GENTRY SMITH EMERGENCY BULKHEAD REPLACEMENT

GENTRY SMITH BULKHEAD
25630 Bates Walk SW
Vashon, Washington 98070

12-2-2022 REVISED BENCHMARK AND BEARING TABLE

New Data for Rock
Bulkhead

12-2-2022 REVISED DIMENSIONS
FROM NEW ROCK BULKHEAD TO BENCHMARK

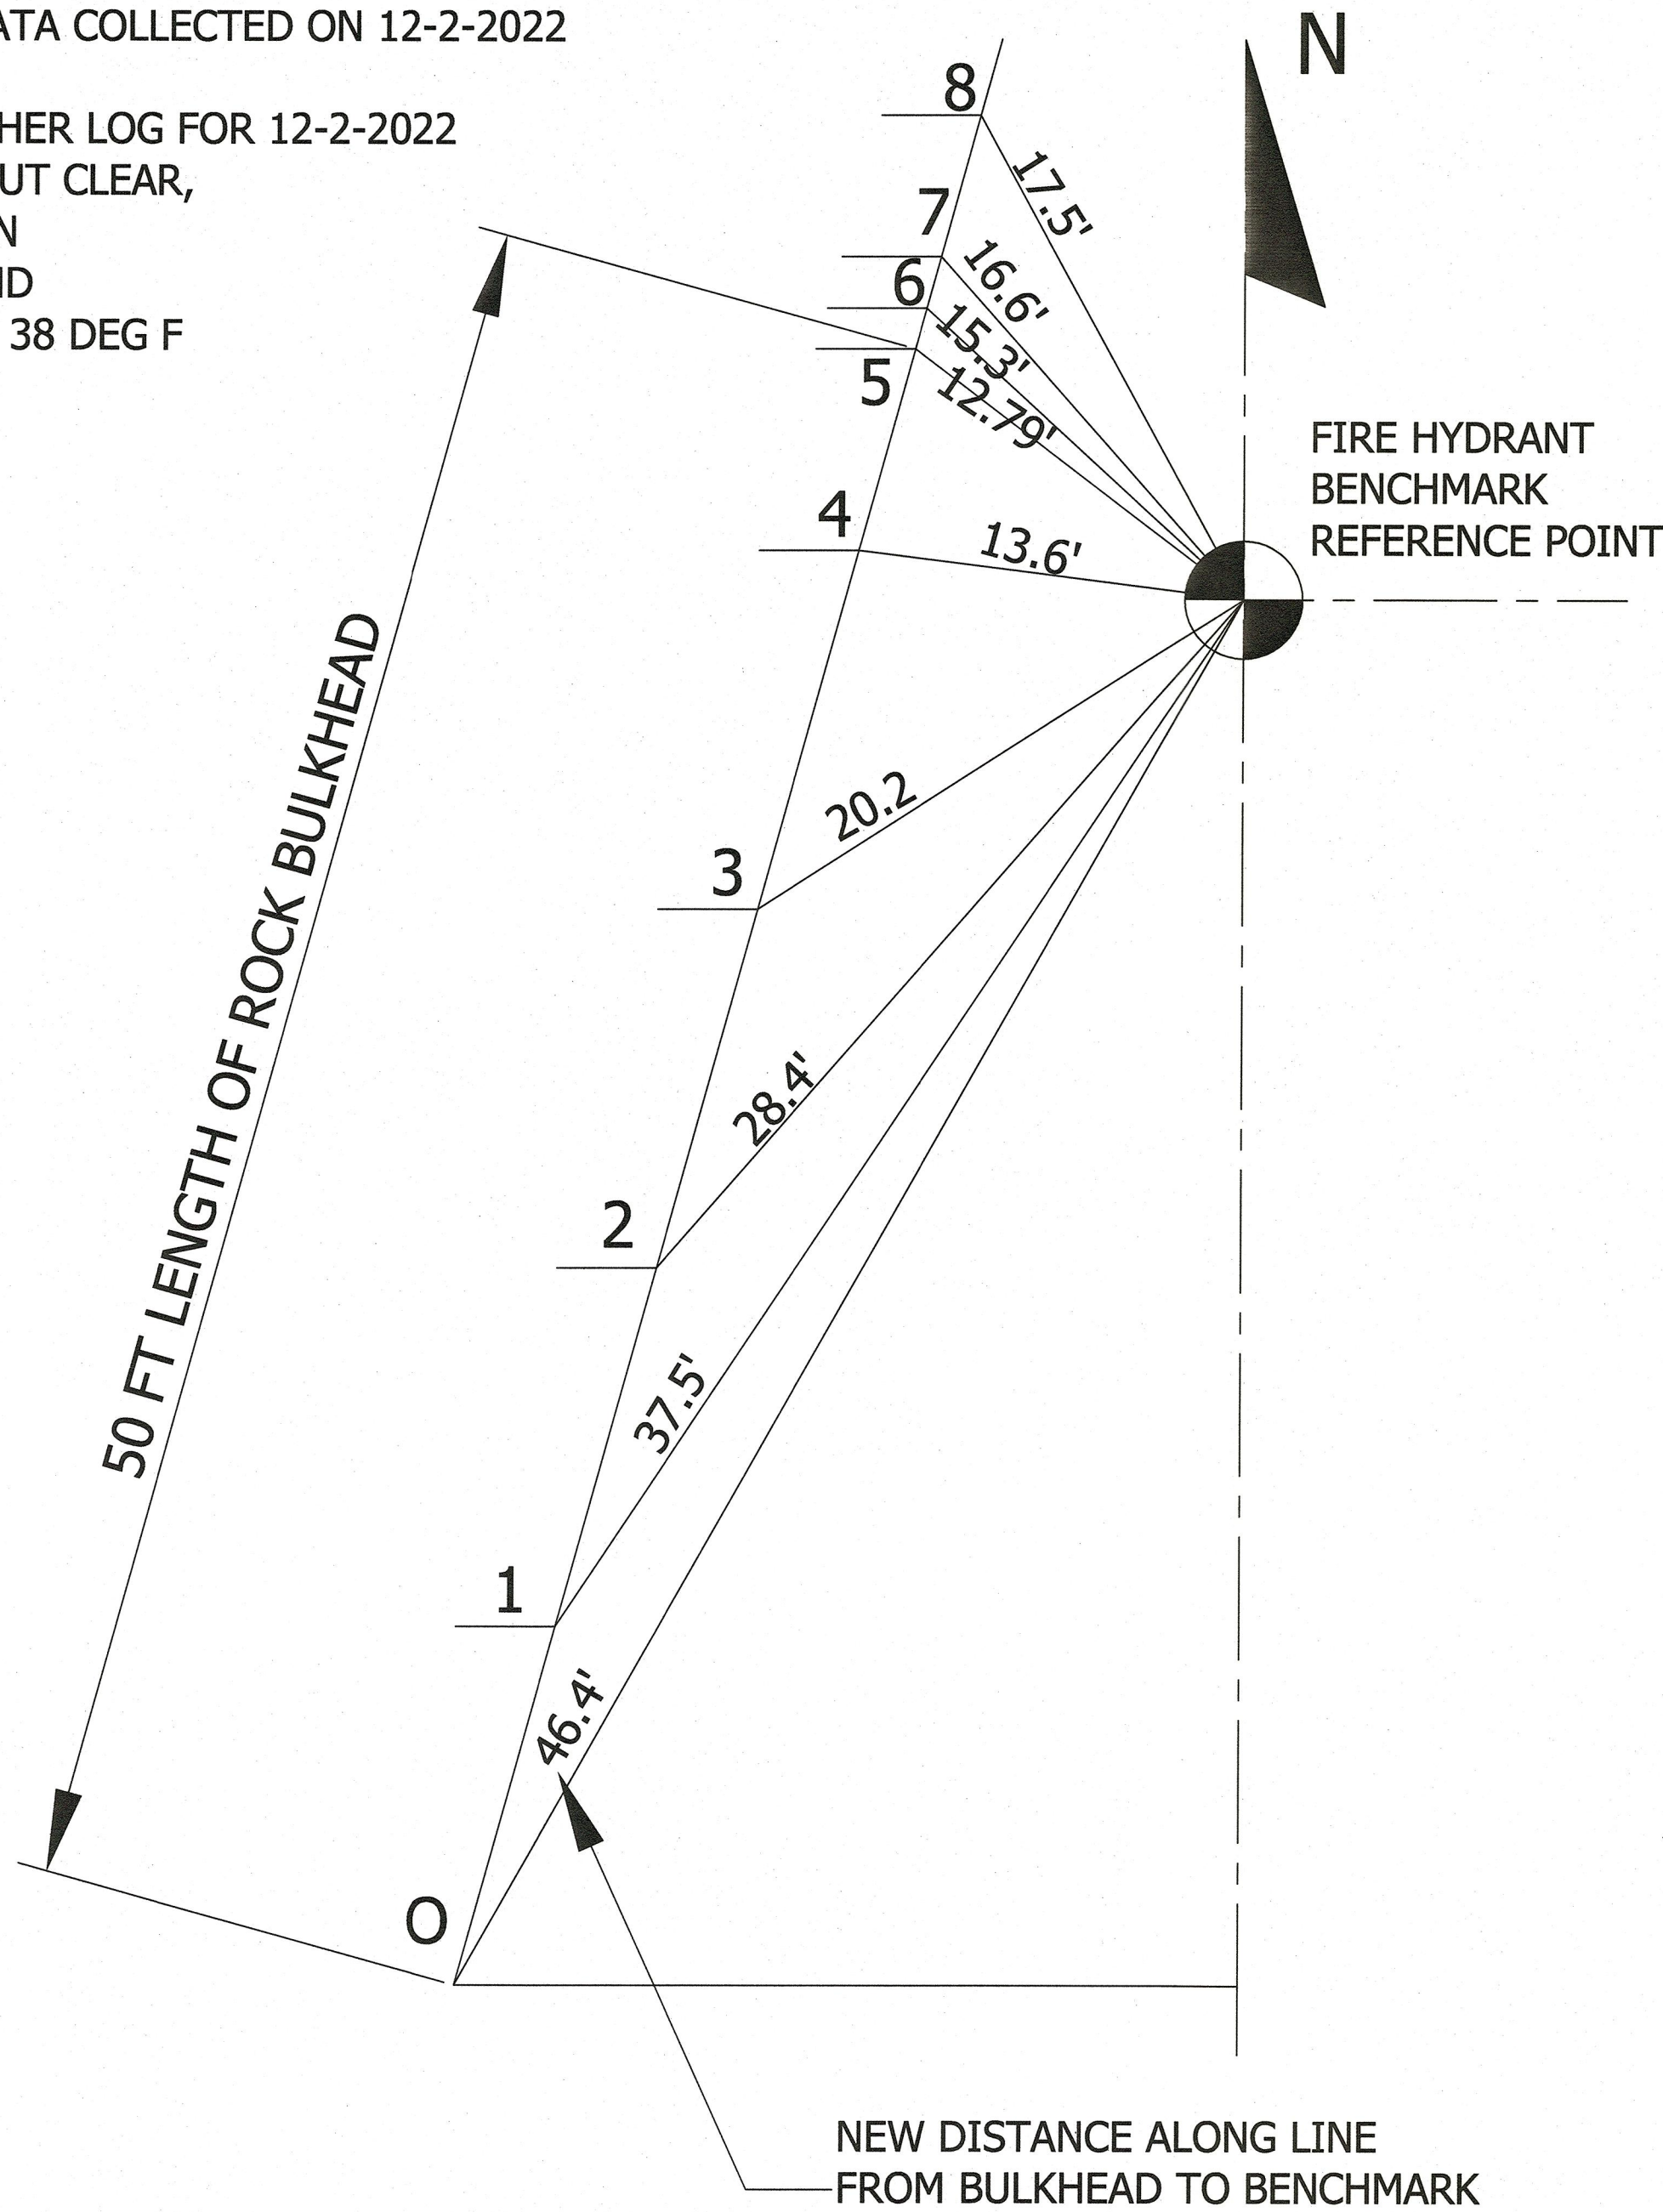
POINT	BULKHEAD HEIGHT ABOVE SAND (in)	MAGNETIC BEARING FROM BENCHMARK	DISTANCE TO BENCHMARK	DISTANCE TO NEXT POINT
0	56"	178 S	46'-5"	0 to 11'-0"
1	61"	185 S	37'-6"	11'-0"
2	66"	191 S	28'-5"	11'-0"
3	66"	209 SW	20'-2-1/2"	11'-0"
4	72"	231 SW	13'-7-1/2"	6'-2"
5	75"	254 W	12'-9-1/2"	1'-3"
6	80-1/2"	256 W	15'-3-1/2"	1'-7"
7	81-1/2"	257 W	16'-7-1/2"	4'-4"
8	82"	270 W	17'-6-1/2"	NA

NEW DATA COLLECTED ON 12-2-2022

NOTE: SEE DRAWING C/2.1 BY ELLISPORT ENGINEERING
FOR ORIGINAL LAYOUT AND DIMENSIONS
